**RESPONSE TO THE EXECUTIVE BOARDS REQUEST OF ADDITIONAL
INFORMATION FOR THE PROJECT ACTIVITY: "ELECTRICITY GRID
INTERCONNECTION SAN GABÁN - MAZUKO - PUERTO MALDONADO"
(REF. NO. 1901)**

Figure 6. Major Isolated Systems in Peru at 2005

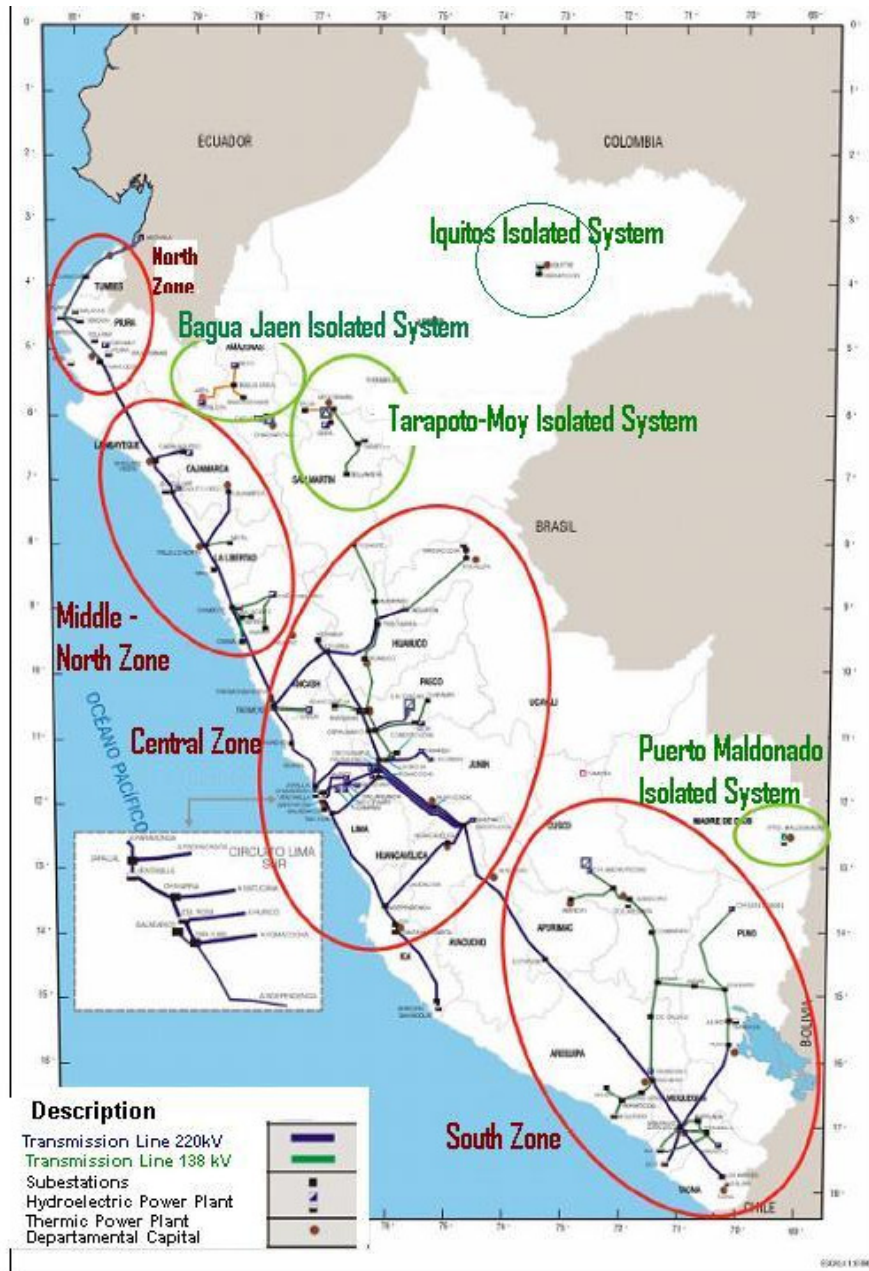
3. THE DOE IS REQUESTED TO FURTHER EXPLAIN HOW IT HAS VALIDATED THE COMMON PRACTICE ANALYSIS, IN PARTICULAR: A) THE FUNDAMENTAL DIFFERENCES BETWEEN THE PROPOSED PROJECT ACTIVITY AND OTHER COMPLEMENTARY TRANSMISSION SYSTEMS AND; B) THE EXCLUSION OF SIMILAR PROJECTS UNDER CONSTRUCTION.

As Puerto Maldonado is considered a major isolated system, another analysis is with the rest of the major isolated systems in Peru. These are identified in the Electricity Reference Plan 2005 – 2014:

From the 4 major isolated systems in Peru only two has a project for interconnection to the national grid like the proposed project activity and are not considered similar¹³. The four systems are evaluated:

- *Isolated system Iquitos*

- *Isolated system Tarapoto – Moyabamba – Bellavista*¹⁴

- *Isolated system Bagua – Jaén*¹⁵

- *Isolated system Puerto Maldonado (project activity)*
